MEMORANDUM

Re: Platform 1500 Planned Development Work Session

PROPERTY ADDRESS: 1512 s 300 w & 309 W 1500 S
PARCEL IDS: 15-13-206-008-0000 & 15-13-206-005-0000
ZONING DISTRICT: CG GENERAL COMMERCIAL
MASTER PLAN: BALLPARK STATION AREA PLAN

LANDSCAPE PLAN

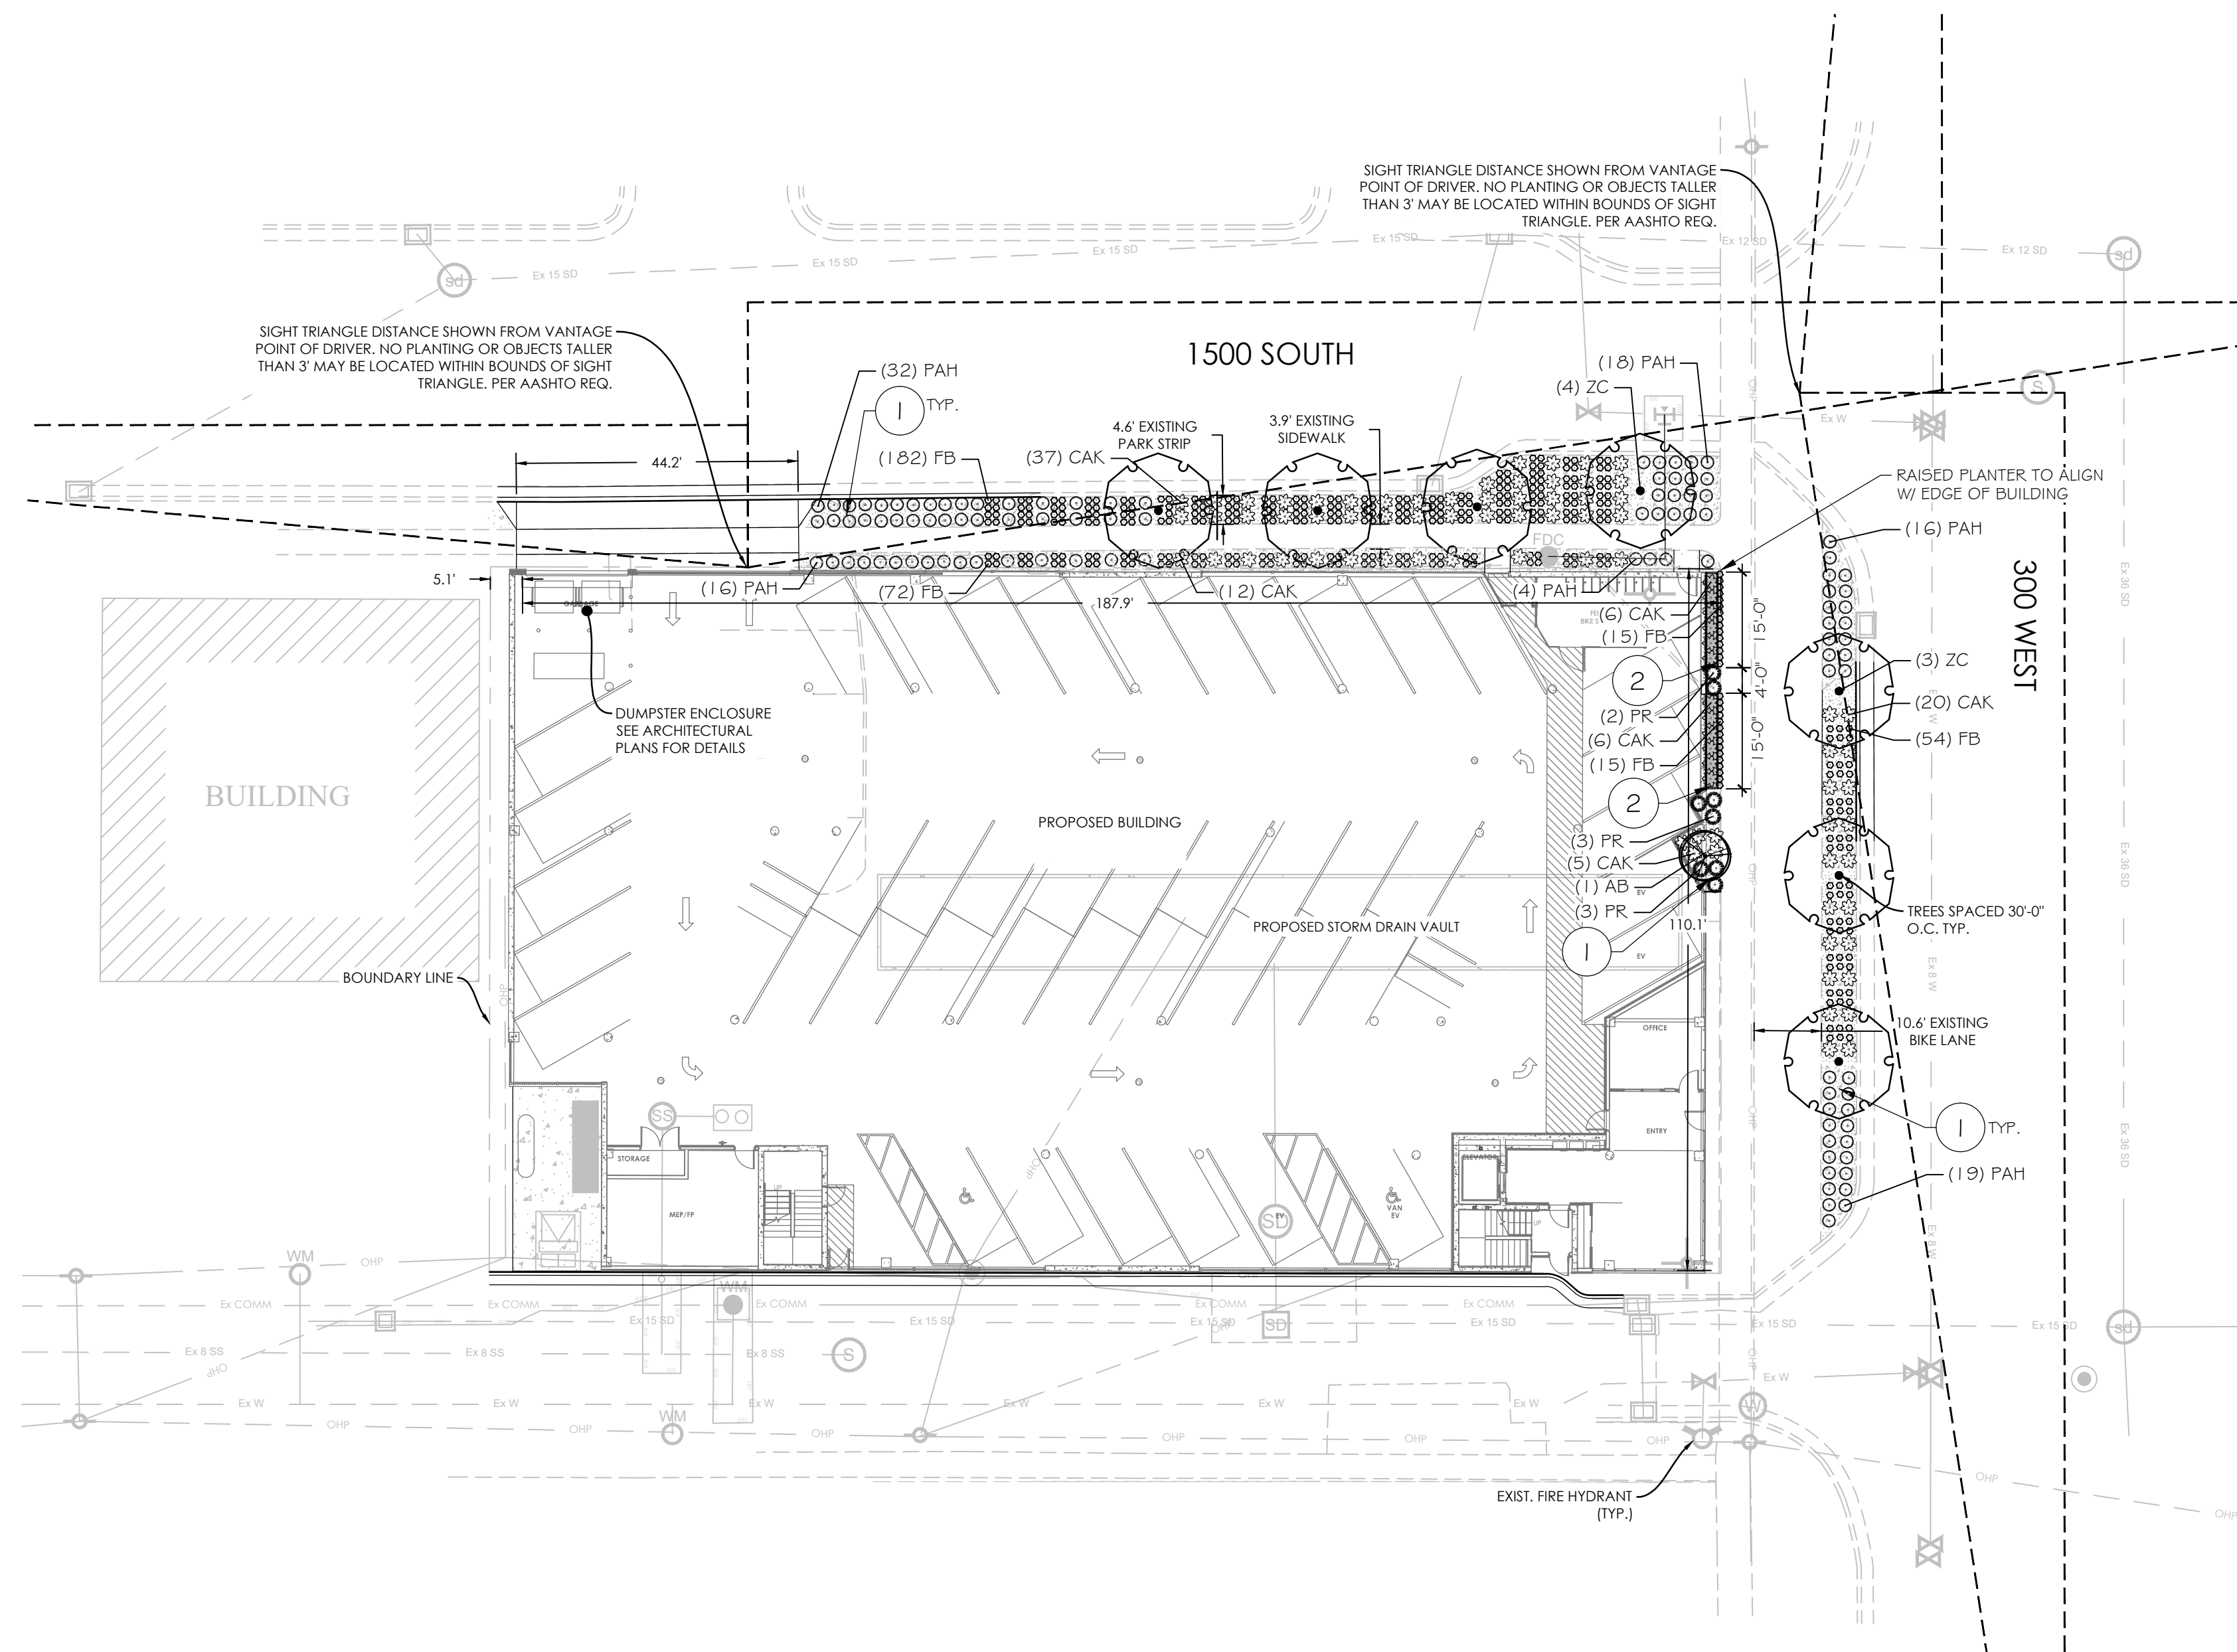
The applicant has proposed additional landscaping within the park strips along 1500 S and 300 W to help offset the landscape yard elimination. 300 W was currently reconstructed and a xeriscape park strip was installed during this time. The current installation of landscaping incorporates strategies to capture storm water and reduce irrigation usage. The applicant has proposed additional trees and shrubs to these park strips to add greenery to the area without providing the landscaping on their property.

There is an existing sidewalk and park strip along 1500 S that the applicant proposes to re-landscape. The applicant has presented two options for landscaping design on 1500 South. Note that these options presented are within the ROW and not on the applicant's property. There is a proposed zero setback along 1500 South.

Option 1 has a metal slated fence that staggers inward to create more landscaping area along the building. Vines along the fence are presented, as well as small trees tucked away in each corner. Staff questions how these trees would thrive in this shaded and partially enclosed environment.

2 North Elevation
1/8" = 1'-0"

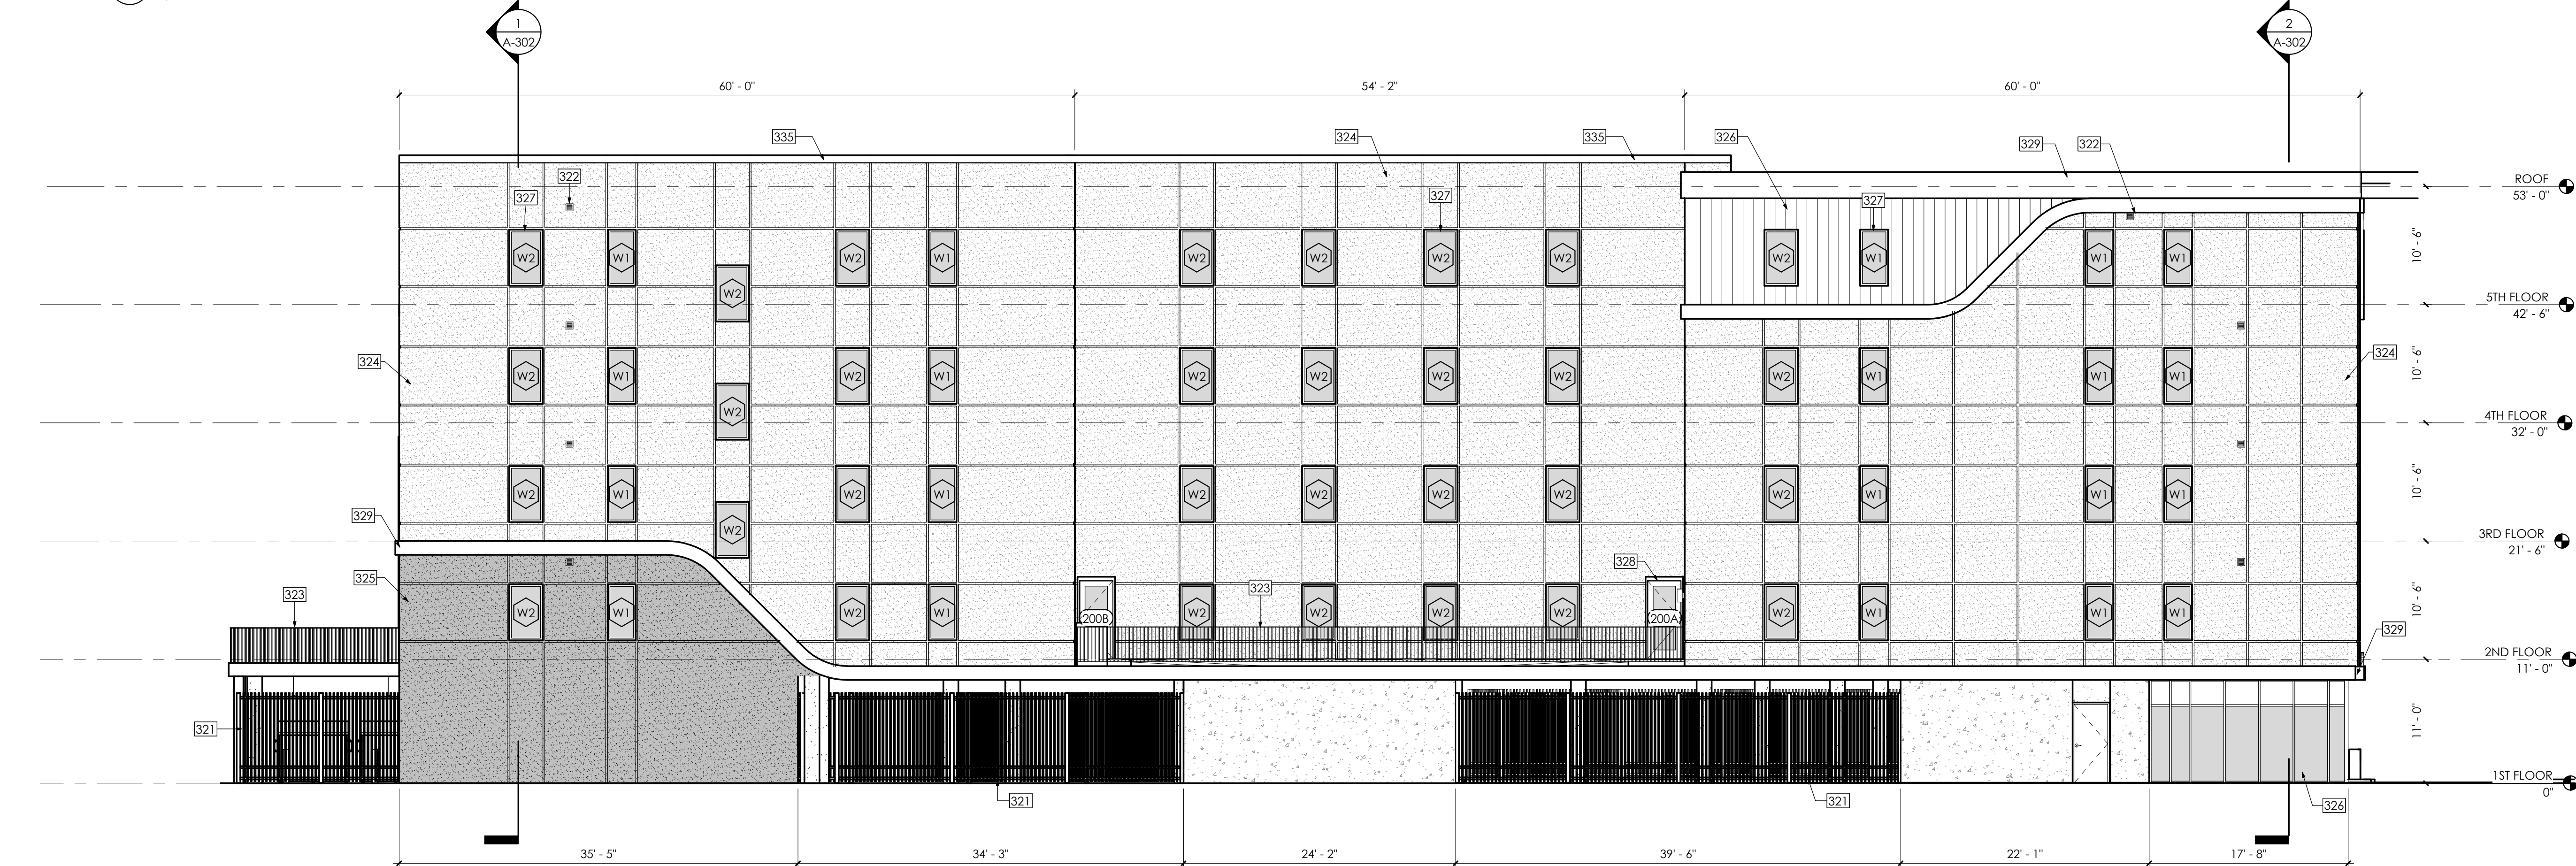
The north elevation facing 1500 S (pictured above) proposes a mix of aluminum fencing, fiber cement panels, and concrete on the ground floor. 1500 S has an existing sidewalk that will remain, but the materials and design of the ground floor design do not create a striking pedestrian experience. Pedestrians would either view into the parking lot or a blank wall. The applicant's construction costs constraints require the ground floor use to be used as parking, so this is a difficult use to screen appropriately to enhance the pedestrian experience. The south elevation on Andrew Ave also lacks an elevated pedestrian design, but no sidewalk exists or is required to be installed on this side. Staff would recommend the focus on pedestrian design be placed on the 1500 S and 300 W facades.

4 West Elevation
1/8" = 1'-0"

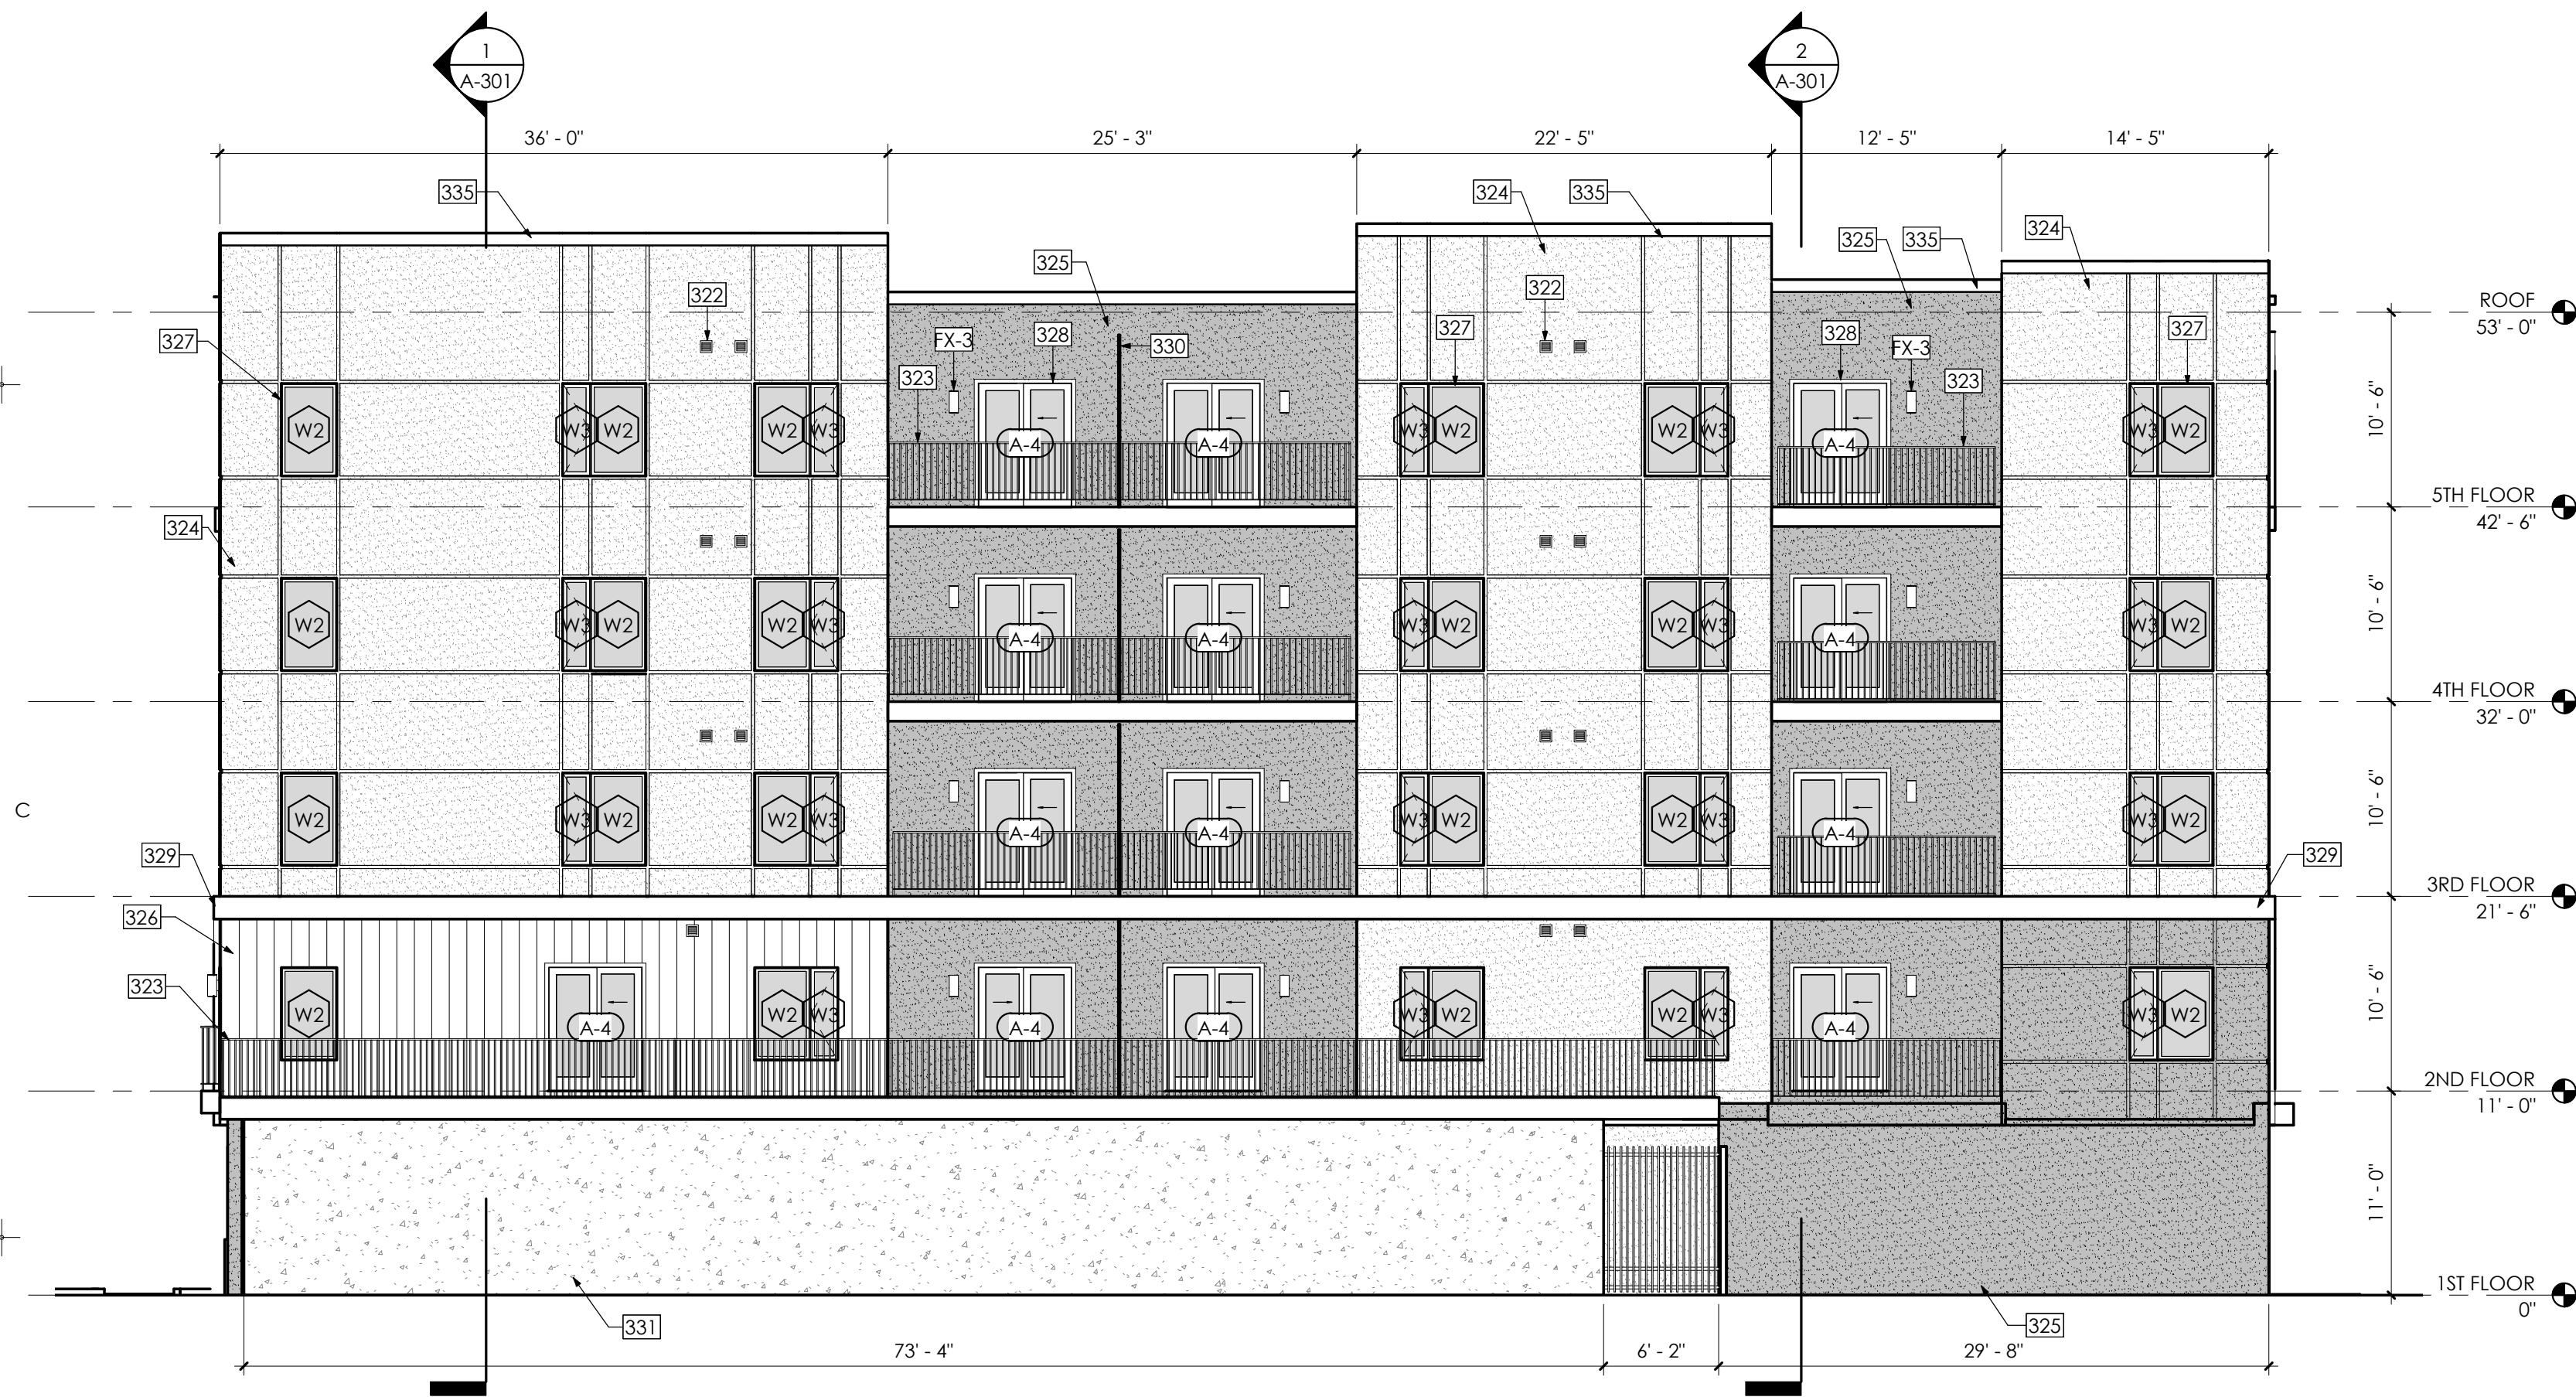
The 300 West ground floor façade would consist of a leasing office for approximately 50' of the façade with glass panels along the side. There is then a 11' transitional space that uses metal fencing to shield from the parking structure while allowing for an additional foot depth of landscaping with two proposed trees. The remaining 50' façade has 2.5' of landscaping – a mix of long grasses and shrubs – backed by a muraled wall. Some benches are placed in front of the leasing office attached to the wall.

The same dimensions and design as Option 1 are proposed, except the landscaping across the muraled façade has elevated raised planter boxes of different heights that add interest and variation to the landscape design. This adds a layered effect while also covering a larger portion of the muraled wall.

Instead of a muraled wall for the northern 50' of the façade, this option proposes a continuation of the metal fencing for the remainder of the building face. The metal fencing would be covered by a crawling vine or other vertical landscape features to shield the parking seen through the slats of the fence.

Regarding all three options, Staff is concerned that the trees presented are under the cantilevered roof of 2.5' and may not thrive in this shaded and enclosed environment. Staff also has a concern with the vertical landscape elements presented in option 3. Their viability and shielding may not be present year-round.
